Topic: Draft 2 Version 9 ENERGY STAR® Television Specification

This letter comprises the comments of the Pacific Gas and Electric Company (PG&E), San Diego Gas and Electric (SDG&E), and Southern California Edison (SCE) in response to the United States (U.S.) Environmental Protection Agency (EPA) Draft 2 Version 9 ENERGY STAR® Television Specification (Draft 2 TV Specification).

Figure 1: Comparison of on-mode power consumption for 8K and 4K TVs Source: CA IOUs Test Results Analysis

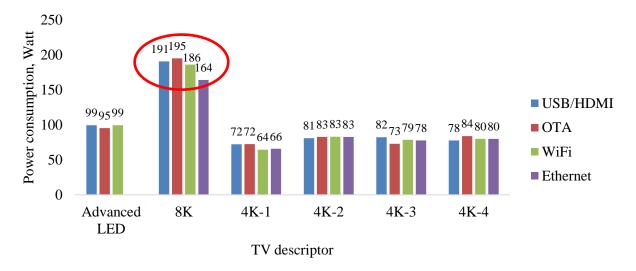
1. The CA IOUs recommend EPA further evaluate on-mode power of 8K TVs in order to determine adequate power requirement for growing 8K TV market.

Our test results indicate that the power consumption of 8K TVs can be more than two times the energy consumption of 4K TVs (Figure 1). Therefore, once 8K TVs represent a larger share of the market, the overall pass rate of market TVs may be lower than the 20 percent pass rate targeted by EPA.

Given the fast pace of change in the TV market, particularly with respect to 8K TVs, we recommend that EPA schedule an update of the ENERGY STAR® Television Specification for approximately 2024, with testing of power consumption for a representative selection of 8K TVs completed by approximately 2023. We note that this schedule is similar to the updated schedule between the Version 8 and Version 9 TV Specification.

Figure 2: On-mode power consumption with ABC On vs ABC Off

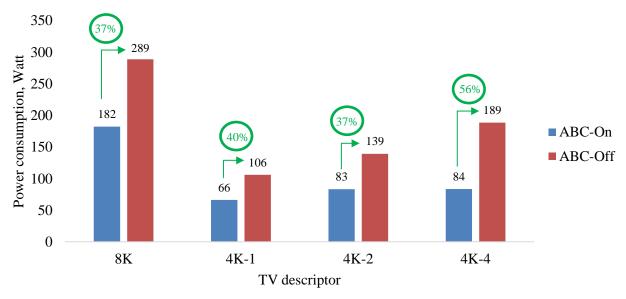
3. The CA IOUs recommend that for TVs where Automatic Brightness Control (ABC) is enabled by default, EPA should include on-mode power with ABC disabled as part of the calculation for power and luminance.

For TVs where ABC is enabled by default, the calculation of on-mode power and luminance does not include on-mode power with ABC disabled. Our test results (Figure 2) found that TV power consumption when ABC is disabled is approximately 37 percent to 56 percent higher than when ABC is enabled. To encourage manufacturers to continue to advance the energy-savings benefits of the ABC feature and to create an incentive to enable the ABC setting by default in all PPSs, we propose the following modification to Equations 1 and 2 in the Draft 2 TV Specification:

Figure 3: Comparison of luminance test results between DOE and CTA 2037C test methods Source: CA IOUs Test Results Analysis

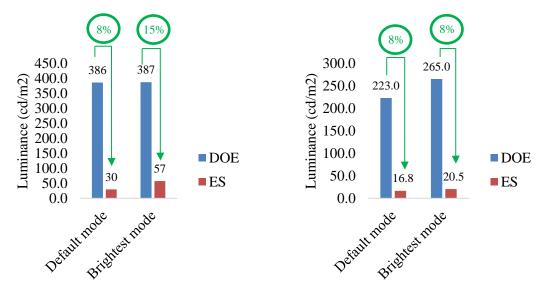
4. The CA IOUs recommend EPA consider the implications of the significantly reduced dynamic luminance measured by using the camera photometer method specified in CTA-2037C: Determination of Television Set Power Consumption and Average Luminance, compared with the spot measurements used by the current federal test method.

In our tests (Figure 3), we found that the luminance measured by using the camera photometer test method specified in CTA-2037C is only eight percent to 15 percent of the luminance measured by using the federal test procedure. While we agree that measuring the luminance over the entire screen is more representative compared with a single spot luminance measurement, we are concerned that measuring luminance of test clips with a significant number of frames in dark scenes may greatly underestimate the power usage of larger TVs (with screen sizes above 65 inches) and TVs with higher resolution (such as 8K TVs which have four times the pixels of 4K TVs). Therefore, we encourage EPA to explore potential approaches to measure and incorporate the luminance of a fully lit screen in the Final TV Specification.

Figure 4: Standby mode power consumption Results

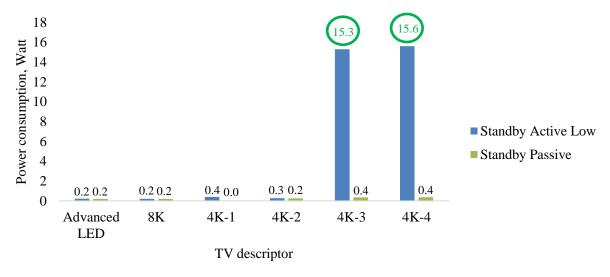
5. The CA IOUs applaud EPA's proposal to lower the Standby-Active, Low Mode Power requirement from 2.0 Watts to 1.0 Watt. We recommend considering further lowering the requirement to 0.5 Watt.

Our test results (Figure 4) indicated that four of six test units used less than 0.5 Watts when the TV was placed in standby mode while connected to a networked device and available to support network wake-up mechanisms. In addition, EPA's published dataset¹ shows that 17 out of 37, or 46 percent, of TVs tested drew no more than 0.5 Watt in Standby-Active, Low Mode. Therefore, we are confident that 0.5 Watt is justifiable for EPA's 20 percent overall pass rate target.

On May 11, 2021, public webinar, EPA also noted that 12 out of 37, 32 percent of TVs tested drew than 10 Watts in Standby-Active, Low Mode. ⁴ Similarly, in our testing, two out of six TVs consumed more than 15 watts in the Standby-Active, Low Mode. We agree with EPA's analysis that the TVs' operating system likely causes the excessive power draw. We encourage EPA to keep a stringent Standby-Active, Low Mode Power requirement, and collaborate with relevant manufacturers to update their operating systems to meet the requirement.
